**Addendum No. 1**  
**City of Coquitlam**  
**Tender No. 81832 - Phase 2**  
**Cedar Drive Upgrades - Sanitary Pump Station to Gilleys Trail**  
 (Consists of 10 Pages)  
 Issue Date: April 17, 2025

**Contract 81832 - Phase 2**  
**CEDAR DRIVE UPGRADES - SANITARY PUMP STATION TO GILLEYS TRAIL**

DRAWING NUMBER:  
**COQ-L5A**

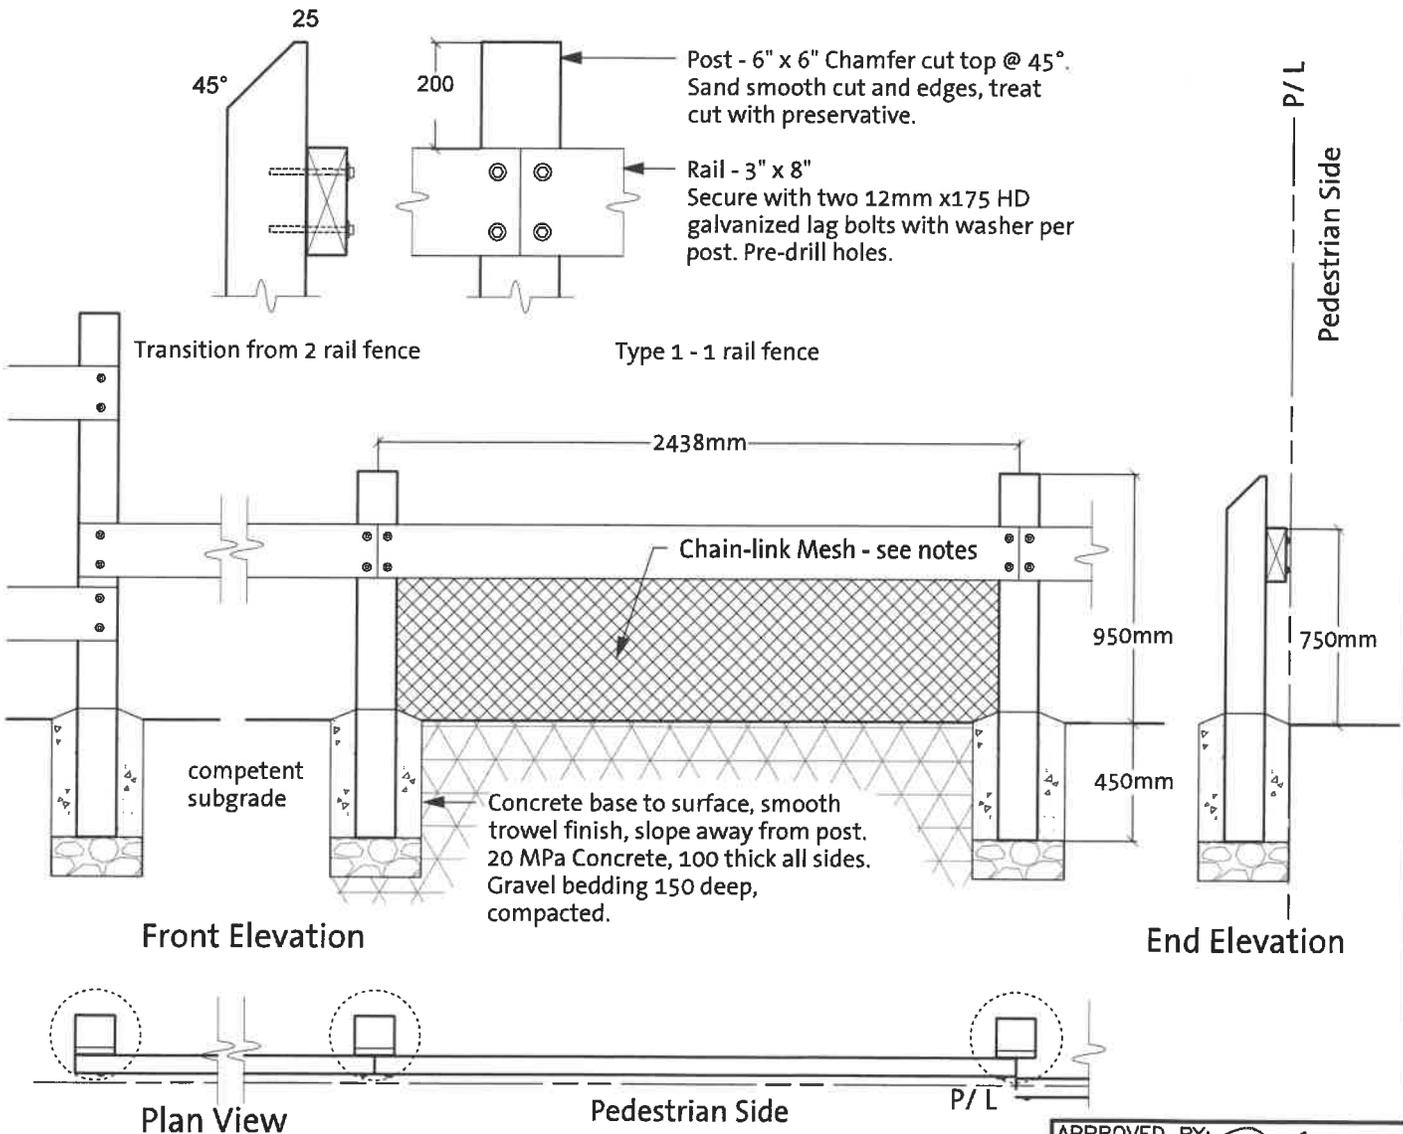
Remove COQ-L5A (DEC/2015) and replace with COQ-L5A (Revision April/2023)
